**ADDENDUM 2 TO THE
FINAL DRAINAGE REPORT
FOR
HOMESTEAD AT STERLING RANCH FILING NO. 2**

**EPCD File No. SF-19-004/CDR-20-012
PCD File No. VR234**

**April 17, 2023
Project No. 25188.29**

**Prepared By:
JR Engineering, LLC
5475 Tech Center Drive, Suite 235
Colorado Springs, CO 80919
719-593-2593**

PROPOSED DRAINAGE MAP (ADDENDUM)

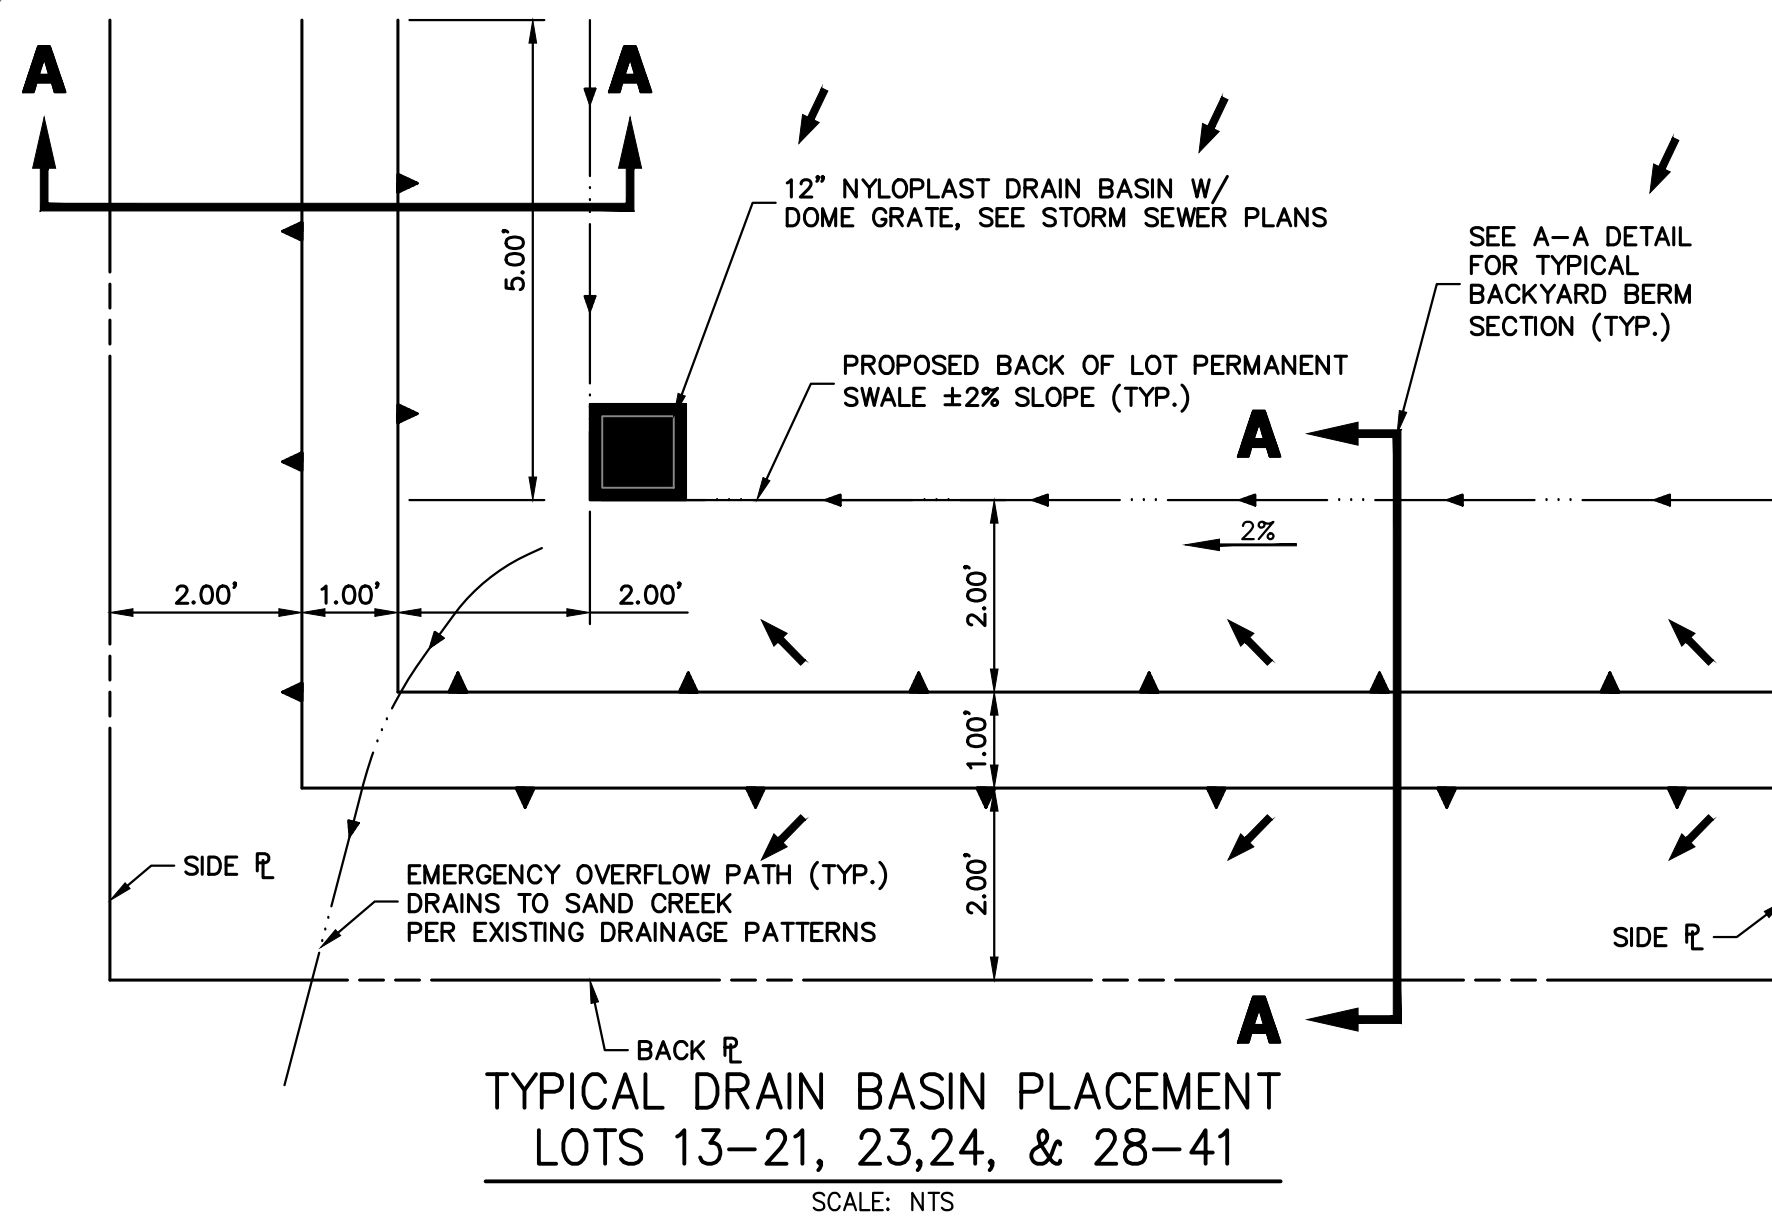
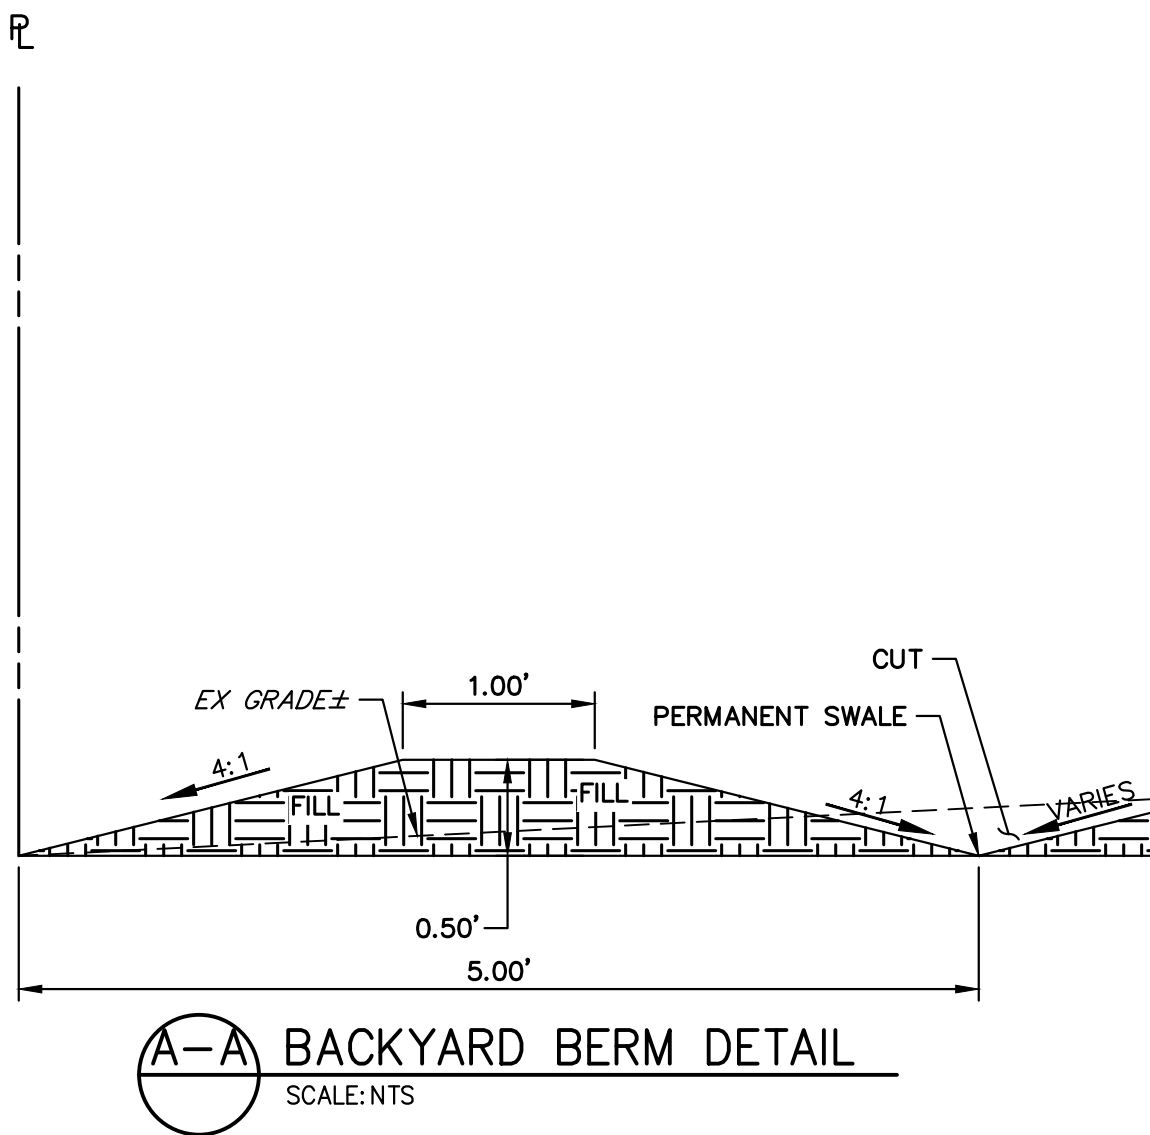
BASIN X1 (0.91 acres), consists of existing residential backyards of lots 36-41 and proposed new lot along the eastern boundary of the site. Italicized text within this section is original and unchanged. Basin X1 increased in size due to the additional lot 2 that will be treated within existing Sand Filter 1. Previously the area for the new lot was located within a tract and was assumed to drain freely to the existing Sand Creek. In accordance with the previous design, a swale/berm and area drain will be used for the new lot to collect the runoff and pipe it directly to existing Sand Filter 1. *Runoff in this basin will be directed via backyard swales/berms towards the rear of the lots where it will be collected in a 12” Nyoplast Drain Basin w/ a 12” dome grate placed in the rear southwest corner of each lot. Each lot will have a half foot berm/swale along the rear and low side of lot that directs water to each inlet, see the detail included on the drainage map, GESC, and Storm plans. Should the inlet in any lot become clogged, the berm will overtop, and flow will continue to Sand Creek. Per the original drainage report by MandS, the estimated flows per each lot in basin X1 = 0.2 cfs for the 100 year storm. The 12” Nyoplast Drain Basins are sized to collect all flows ($Q_5 = 0.7$ cfs, $Q_{100} = 2.6$ cfs) in both the 5 and 100 year storms. Collected flows will then be piped to a proposed full-spectrum sand filter, with a 12-hour drain time and a 4” perforated underdrain. The treated flows from the sand filter will be discharged via an outlet structure to the adjacent Sand Creek. See the comparison table at the end of the Detailed Drainage Discussion section to see the changes to Basin X1.*

BASIN W1 (0.84 acres), consists of existing residential backyards of lots 19-23 and a proposed adjustment to lot 24 (new lot 1) along the southeastern boundary of the site. Italicized text within this section is original and unchanged. Basin W1 decreased in size due to the adjustment to lot 24 decreasing the lot area. Only the runoff from lot areas are collected and treated in existing Sand Filter 2 and since the lot size is decreasing, the swale/berm configuration along the back of the lot is also decreasing in length. *Runoff in this basin will be directed via backyard swales towards the rear of the lots where it will be collected in a 12" Nyoplast Drain Basin w/ a 12" dome grate placed in the rear corner of each lot (DP3). Each lot will have a half foot berm/swale along the rear and low side of lot that directs water to each inlet, see the detail included on the drainage map, GESC, and Storm plans. Should the inlet in any lot become clogged, the berm will overtop, and flow will continue to Sand Creek per existing drainage patterns. The 12" Nyoplast Drain Basins are sized to collect all flows ($Q_5 = 0.6$ cfs, $Q_{100} = 2.2$ cfs) in both the 5 and 100 year storms. Collected flows will then be piped southwest via 12" HDPE pipe following the rear lot lines towards DP3.1, where flows in the pipe combine with collected flows from Basin X2 ($Q_5 = 1.3$ cfs, $Q_{100} = 4.6$ cfs). See the comparison table at the end of the Detailed Drainage Discussion section to see the changes to Basin W1.*
